Docket Number:	19-AAER-04
Project Title:	General Service Lamps
TN #:	229971
Document Title:	NEMA Comments on CEC Notice of Proposed Action General Service Lamps (Expanded Scope) 19-AAER-04
Description:	N/A
Filer:	System
Organization:	Alex Boesenberg/NEMA
Submitter Role:	Public
Submission Date:	10/7/2019 9:08:01 AM
Docketed Date:	10/7/2019

NEMA Comments on CEC Notice of Proposed Action General Service Lamps (Expanded Scope) 19-AAER-04

NEMA Comments on CEC Notice of Proposed Action General Service Lamps (Expanded Scope) 19-AAER-04

Figure 1: NEMA Assessment of Overestimation of DOE IRL Shipments

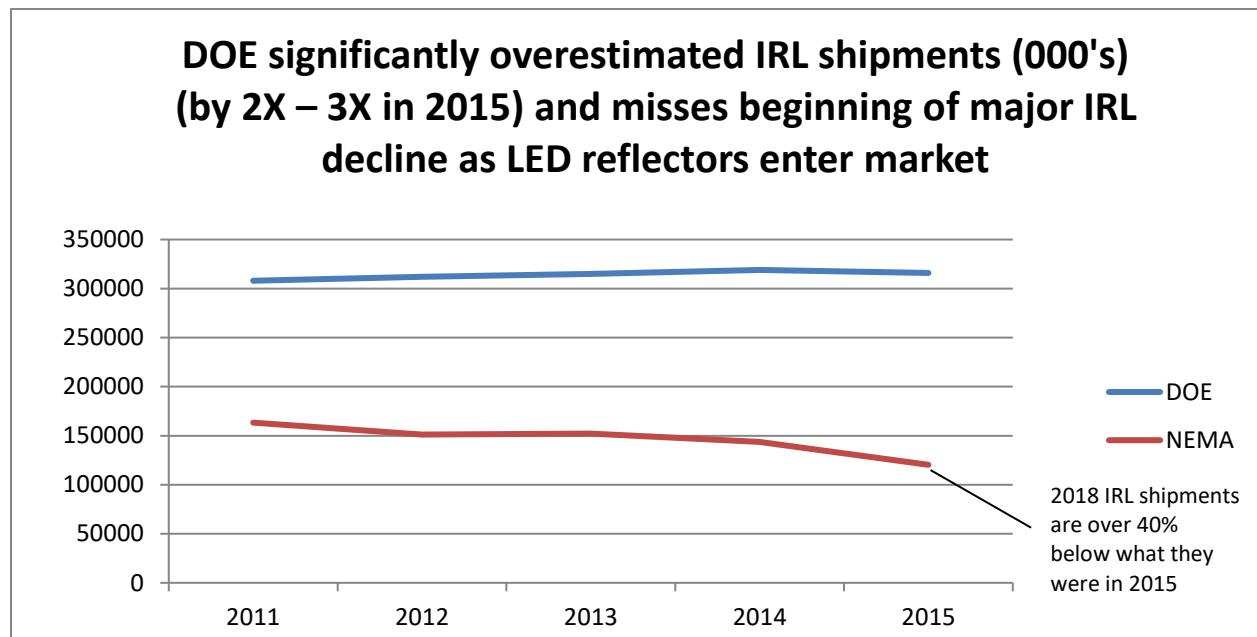
The flaw is evident in the LBNL estimate in Table 1 of its Report that there were 960 million large diameter reflector lamp sockets in the U.S. in 2015, approximately 355 million sockets greater than shipment and reflector lamp service life data can possibly support (see above). The LBNL estimate of reflector lamp sockets was derived from inaccurate shipment data in a U.S. Department of Energy report that overstated incandescent reflector lamp (IRL) shipments by two to three times.¹⁷ If the number of IRL shipments and the stock of reflector lamps was as high as LBNL estimated, NEMA members would have sold a lot more reflector lamps than they actually did. They did not sell anywhere near the DOE estimate.¹⁸

The Low LED Scenario repeated in the Supplemental Staff Analysis derived from the LBNL Report as reflected in the CASE study is so inherently misleading and not credible that it should be ignored entirely. That the High LED Scenario is based on adjustments to the Low LED Scenario is grounds for disregarding that Scenario as well. The better course of action would have been to begin an entirely new analysis using traditional means for estimating lamp stock. There are far fewer large diameter incandescent reflector lamps sold and installed than the CEC staff has estimated based on unreliable estimates of others.

Figure 2: IRL Shipments 2011-2018. Source: NEMA Lamp Index

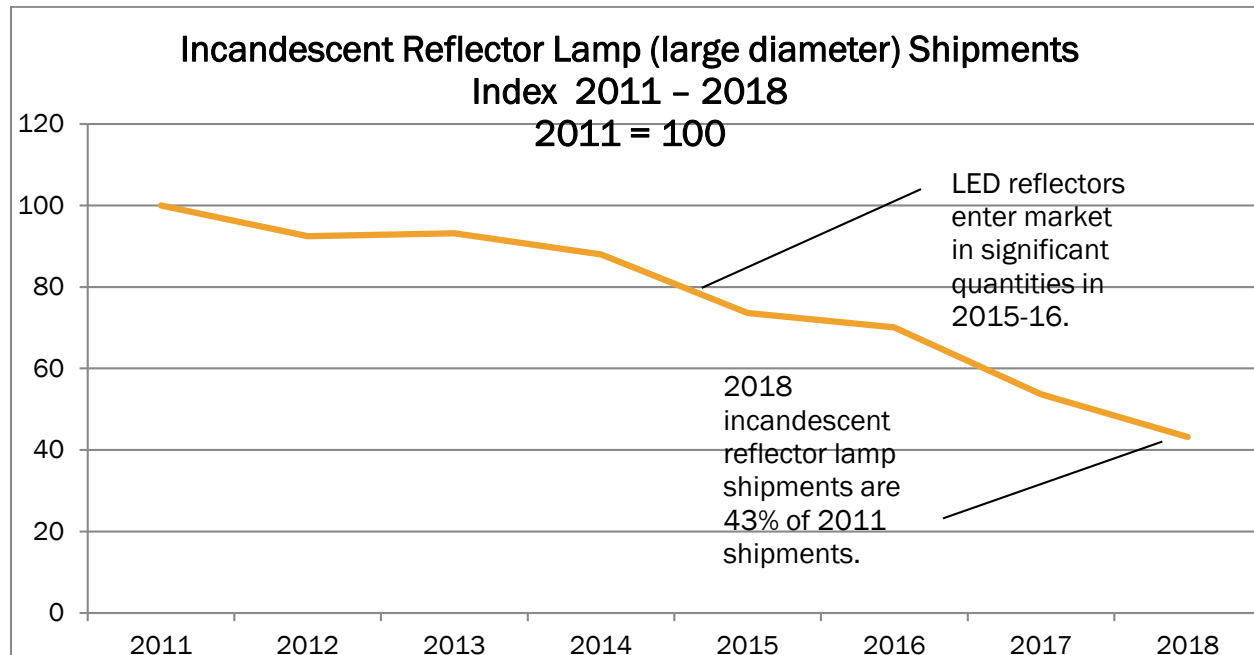
In addition to the fact that sheer number of incandescent reflector lamps shipped in the U.S. in 2015 was exaggerated by a factor of nearly 3X, an updated index of incandescent reflector lamp shipments from 2011 through 2018 looks like this, displaying dramatically declining shipments of these lamps nationwide after 2015.

The Supplemental Staff Analysis “assumption” that LED reflector lamp shipments were approximately 50% of the category in 2017 is close (50.6%); however, CFL reflector lamp stock still accounted for 1.4% of the category in 2017 meaning that incandescent reflector lamps were 48% of the category in 2017. **The primary problem with the “High LED Scenario” is its reliance on the large overstatement of the number of total reflector lamp sockets found in the “Low LED Scenario.”** The effect of this overstatement is reflected in the fact that large diameter incandescent reflector lamps in sockets in California in 2017 are closer to 40 million (72.6 million * 56%), not 55.5 million as the Supplemental Staff Analysis’ Table 5 represents.¹⁹ That share of incandescent reflector lamps in reflector lamp sockets is declining as we write. In 2018, incandescent reflector lamp shipments fell 20% over 2017, and the rate of decline has escalated to 35% in the first six months of 2019 over the first six months of 2018. **LED reflector lamp shipments are now two-thirds of the large diameter reflector lamp category**
